March 30, 1987

The Commission has issued the enclosed Amendment No. 60 to Facility Operating License No. NPF-12 for the Virgil C. Summer Nuclear Station, Unit No. 1. The amendment consists of changes to the Technical Specifications in response to your application dated June 27, 1986, as supplemented November 21, 1986, and February 25, 1987.

VIRGIL C. SUMMER NUCLEAR STATION, UNIT NO. 1

Amendment No. 60
License No. NPF-12

FIGURE 3.2-3 RCS TOTAL FLOW RATE VS. R THREE LOOP OPERATION

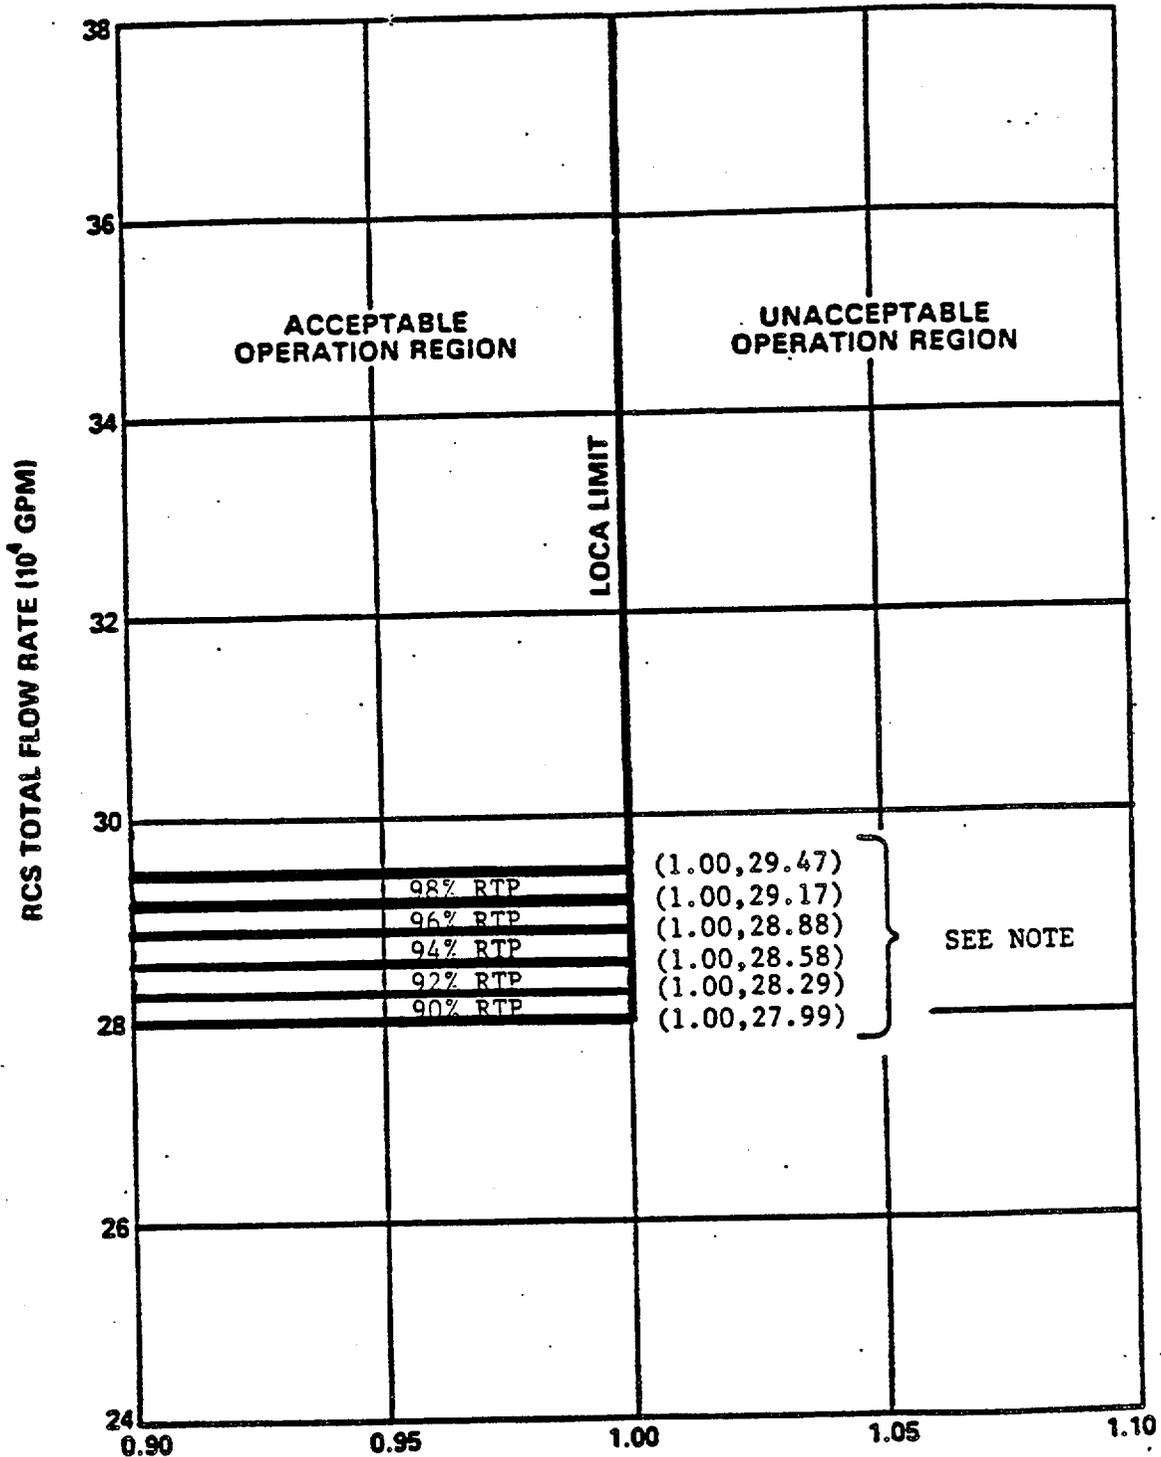
The TS change also modifies Figure 3.2-3, "RCS Total Flow Rate Vs R-Three Loop Operation," to reflect the 2.1% RCS flow uncertainty value. Previously (Ref. 3), the licensee had submitted an analysis to support a request to modify this figure to define allowable power levels for an RCS flow rate less than 100% of thermal design flow (TDF) with corrections for flow measurement uncertainty. A 2 to 1 power/flow tradeoff for RCS flow deficits of up to 5% was approved in Amendment No. 37 (Ref. 4). The maximum power level was to be reduced by 2% for each 1% reduction in flow in the range from 100% to 95% total flow. Figure 3.2-3 was modified to show the allowable RCS flow for reduced Rated Thermal Power (RTP) up to 10% (in the range from 100% to 90% RTP) in increments of 2% RTP. However, with the present request (Ref. 1) for reduction of RCS flow measurement uncertainty from 3.5% to 2.1%, the previous TS values for RCS flow for this figure are altered and need to be changed. These changes are included. It is noted that the TDF was reduced from 98,000 gpm per loop to 96,200 gpm (288,600 gpm for 3 loops) in Amendment No. 45 to the TS when the Westinghouse BART Evaluation Model was adopted. We have examined the proposed changes in Figure 3.2-3 and have found the changes to be in agreement with the effect of the new measurement uncertainty value of 2.1%. The changes are, therefore, acceptable.

(2) Figure 3.2-3 - RCS Total Flow Rate vs. R-Three Loop Operation - (Page 3/4 2-10)

This figure has five incremental changes in RTP from 100% down to 90% with corresponding reduction in values for RCS total flowrate in gpm down to 95%. Because of the change in RCS flow measurement uncertainty from 3.5% to 2.1%, the values shown in Figure 3.2-3 needed to be adjusted. We found these changes to be acceptable as explained in the evaluation.

MEASUREMENT UNCERTAINTIES OF 2.1% FOR FLOW
AND 4.0% FOR INCORE MEASUREMENT OF $F_{\Delta H}^N$ ARE
INCLUDED IN THIS FIGURE
